CITY OF MISSION, KANSAS
COMMUNITY DEVELOPMENT COMMITTEE

WEDNESDAY, APRIL 4, 2018

RE: Tidal Wave Auto Wash Preliminary and Final Site Plan, 6501 Johnson Dr

STAFF REPORT
Planning Commission Meeting March 26, 2018

2 SIDE ELEVATION
SCALE: 1/4"=1'-0"

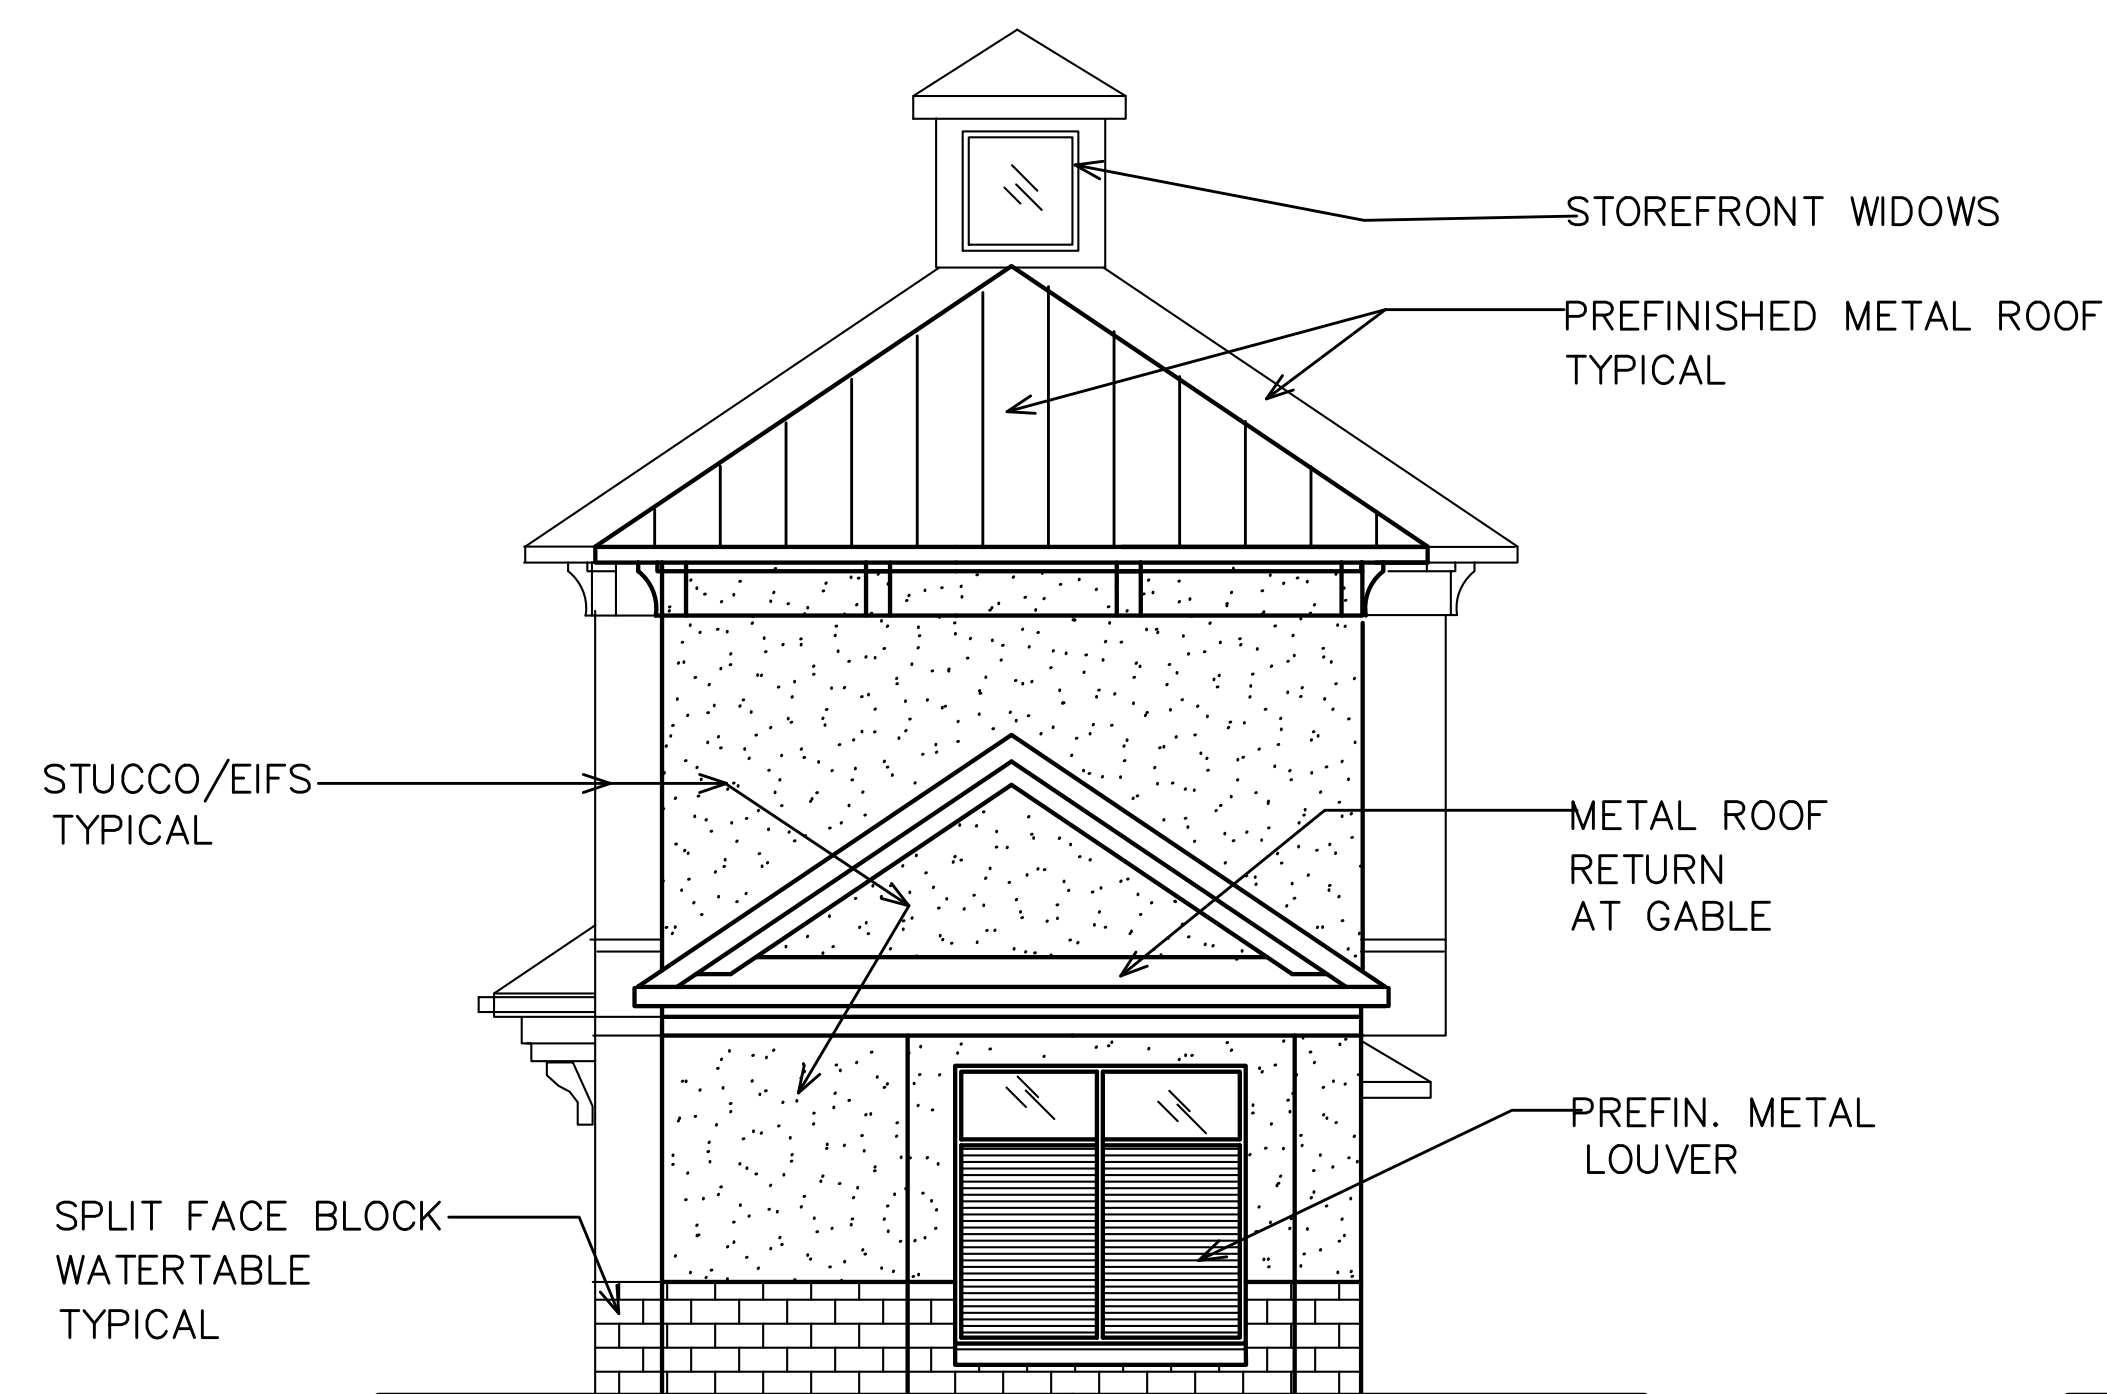
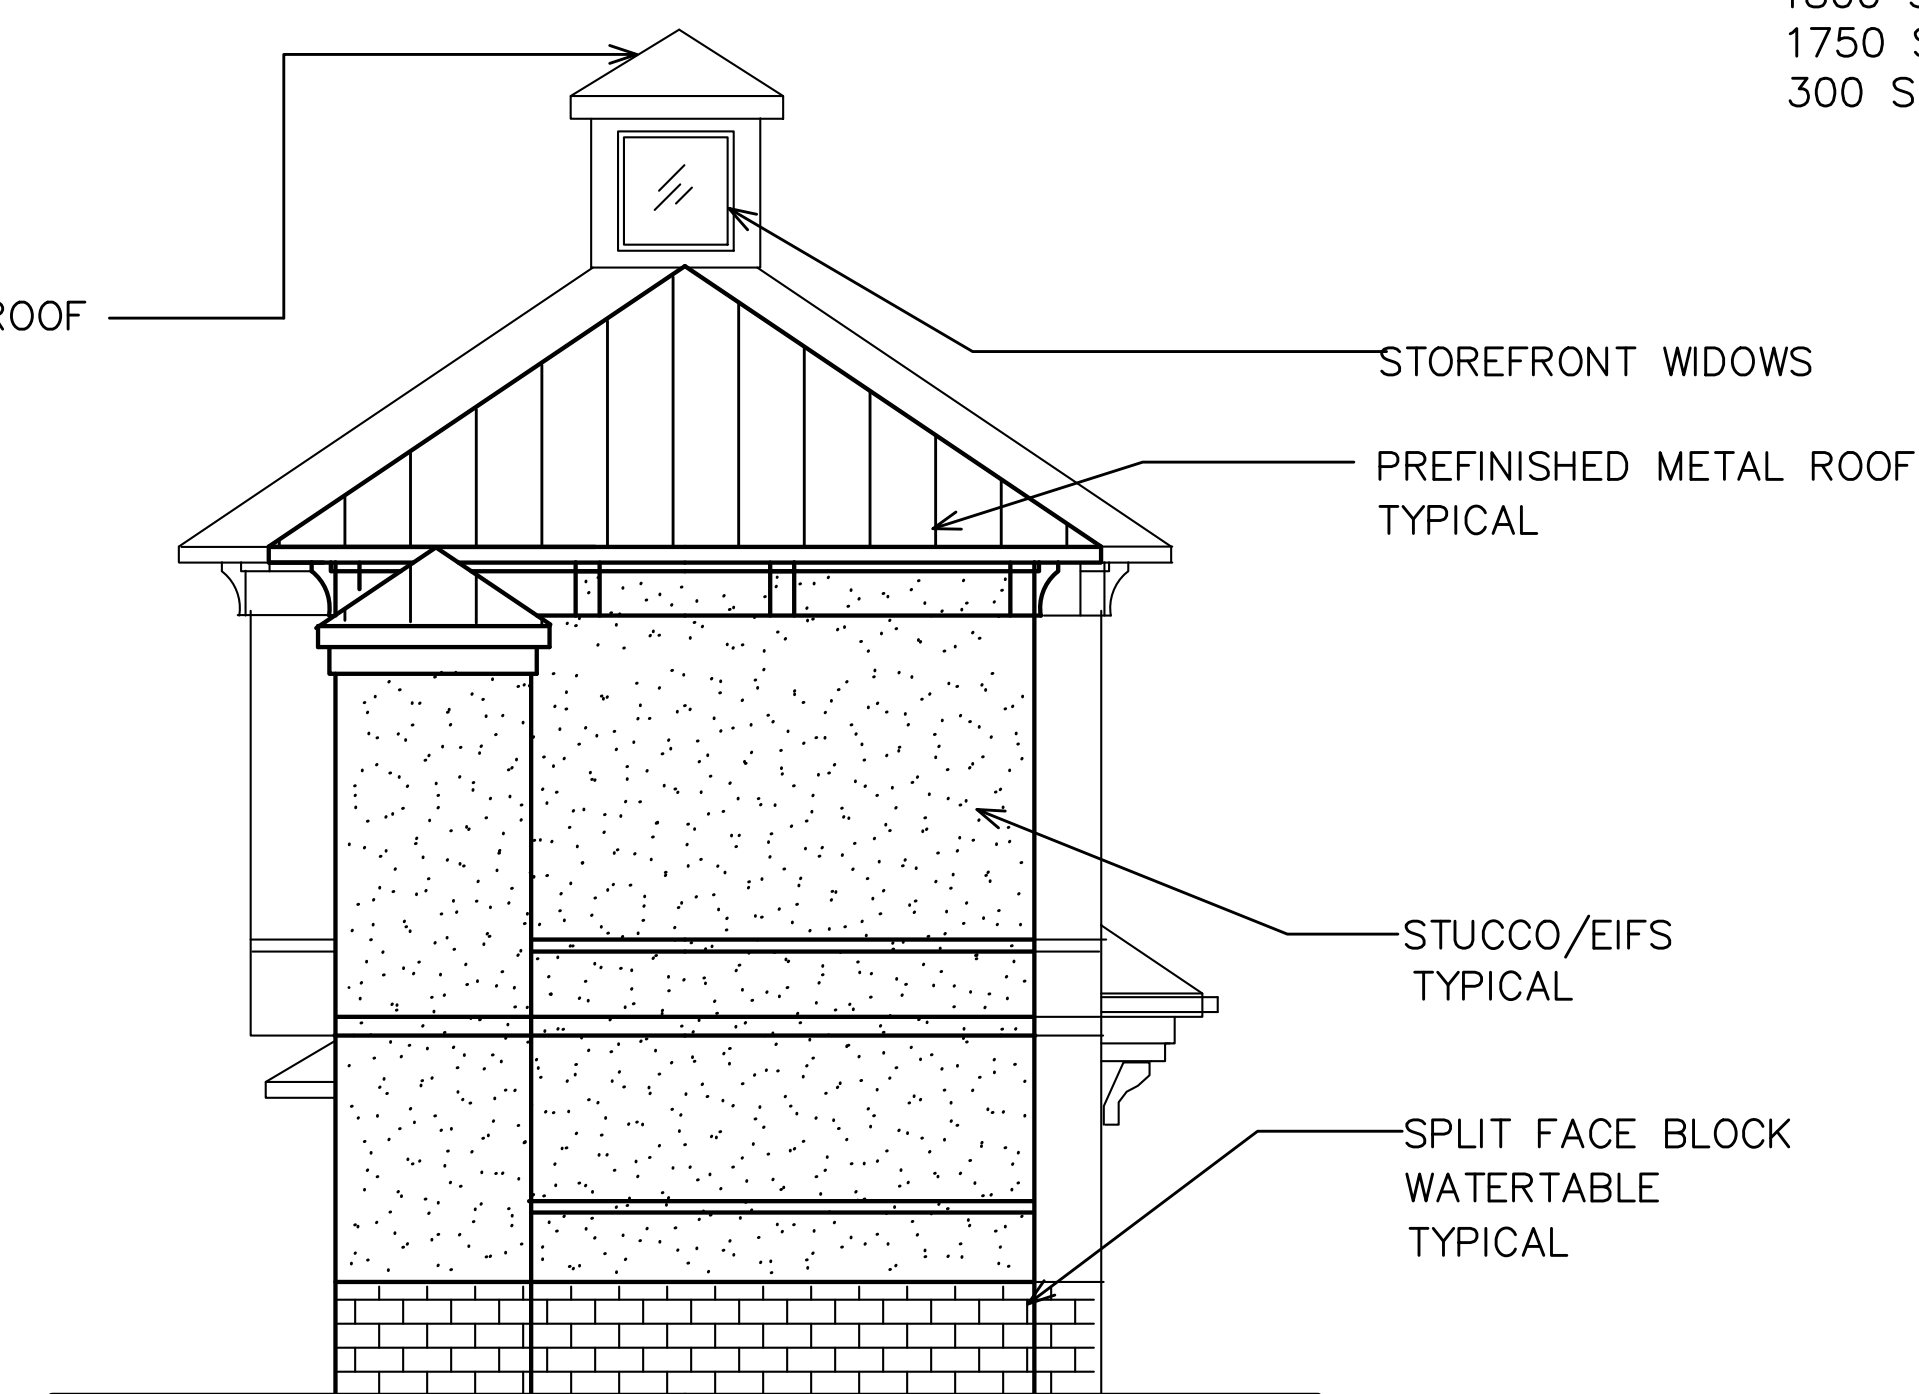
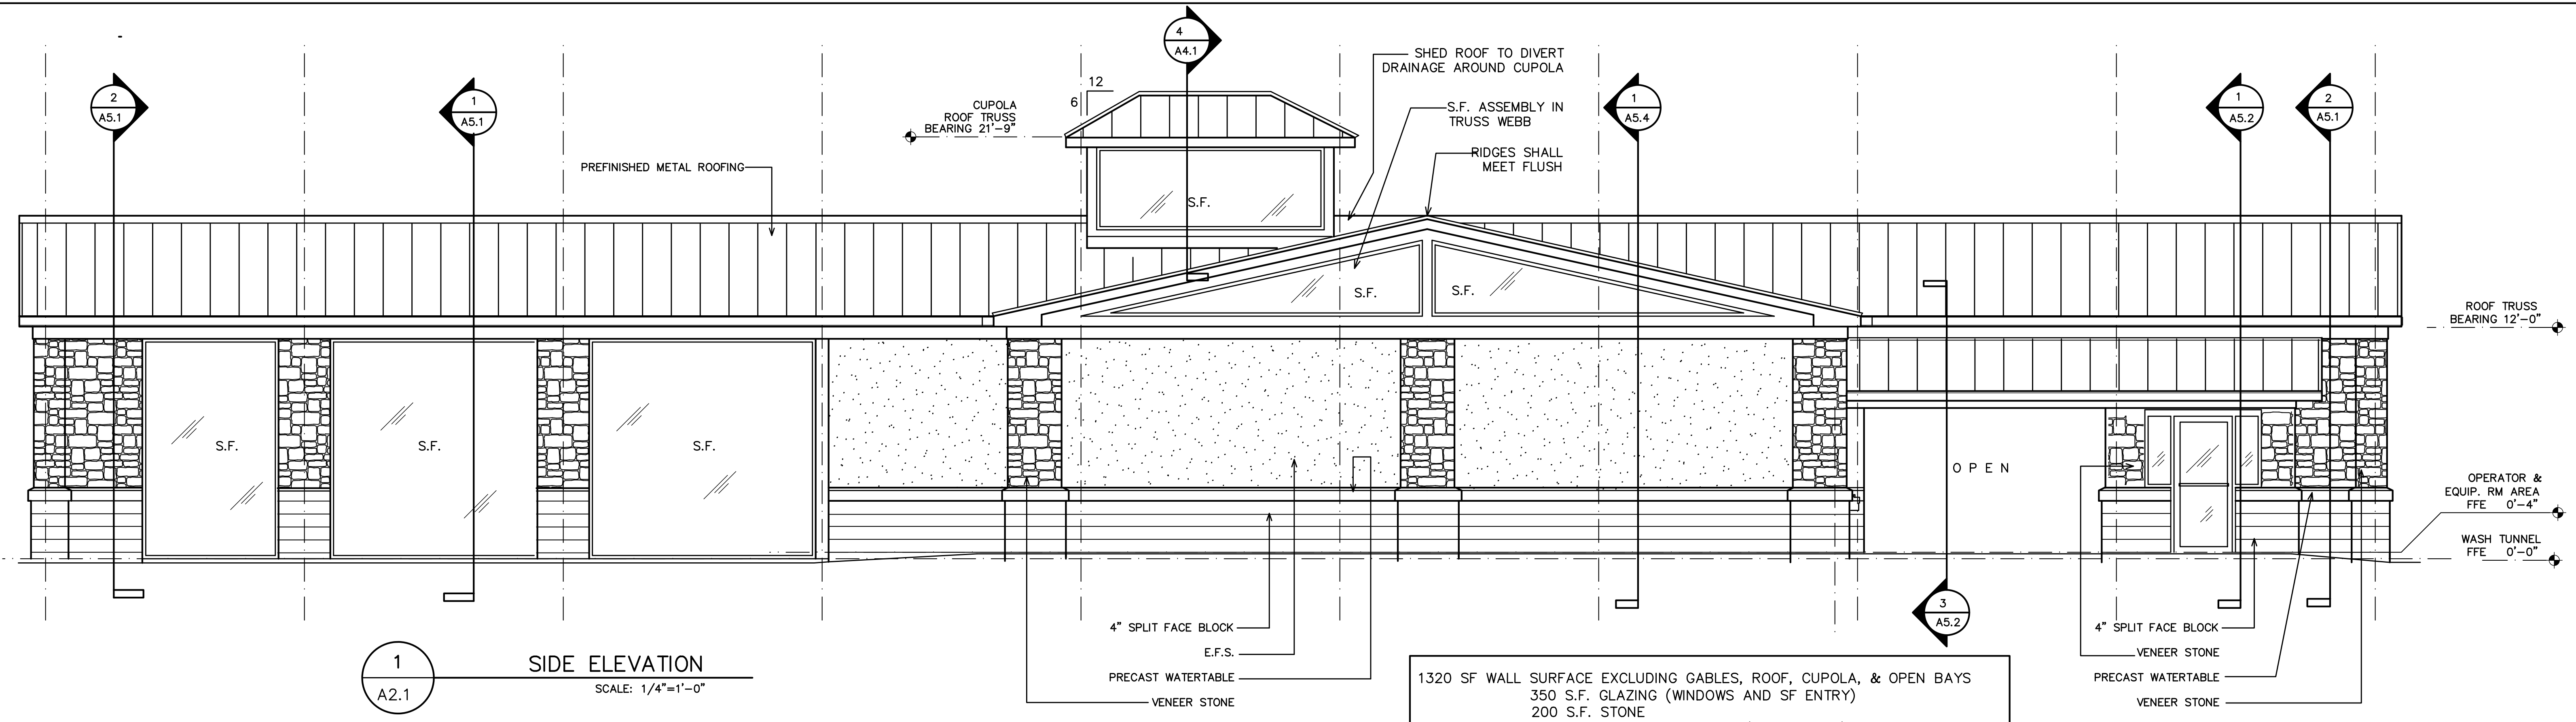
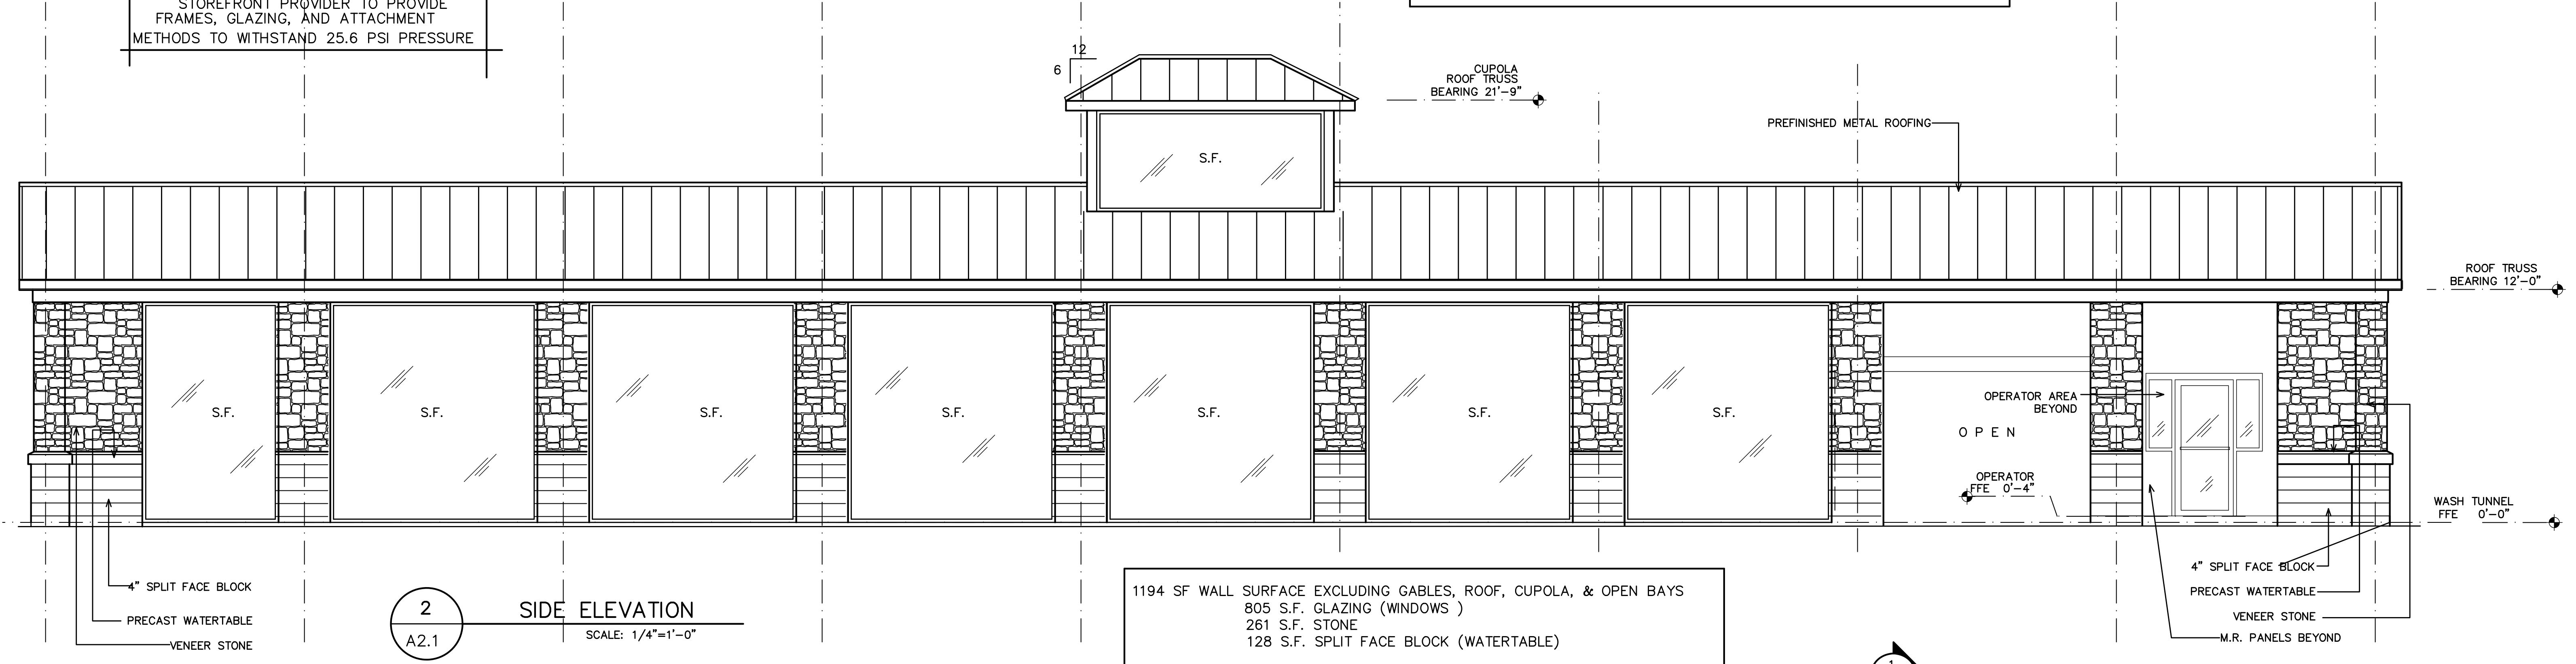
Due to the aforementioned one-story structure not meeting the required 26' building height to be considered a Low-Rise building type, the taller structure not meeting the definition of a Parking Structure building type, and the material comments outlined above, the full score for this portion of the plan review has not been achieved. This can be rectified by the applicant revising the design and providing additional details for these structures to comply with the intent of the FBC building type and architectural treatment requirements.
Score: 2.5/6 points

For these reasons, the full score for this portion of the plan review has not been achieved. This can be rectified by the applicant revising the elevations of these proposed structures, walls, and railings (if any are needed for safety) to reflect proposed materials and finishes, and by submitting samples of these materials for review.

- Provide calculations indicating windows and doors of commercial establishments occupy no less than 60% of the total storefront, from sidewalk grade to a distance of 18' above the sidewalk grade.
